Access Compliance Report

Public Rights-of-Way

(Pedestrian Signals)

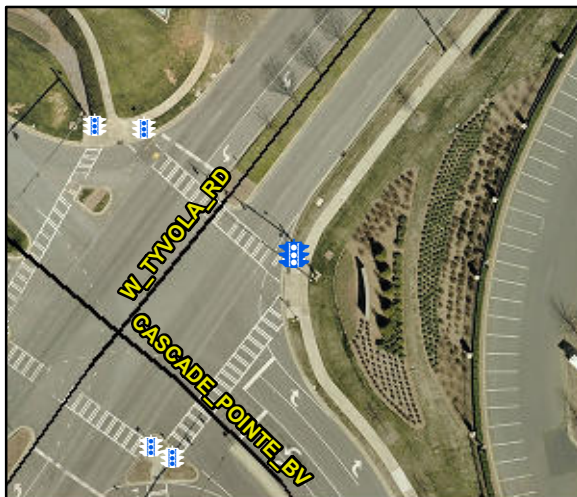
Surveyor Notes: TEXT HT 3/8

PROW/ADA: R410.6, TMUTCD 4e.08, R404.2, R406.2, DMS-11132, R209.1, MUTCD 4e.10

Possible Solutions: Replace Signal Push Button With APS Button on New Post. Remove & Replace Sign.
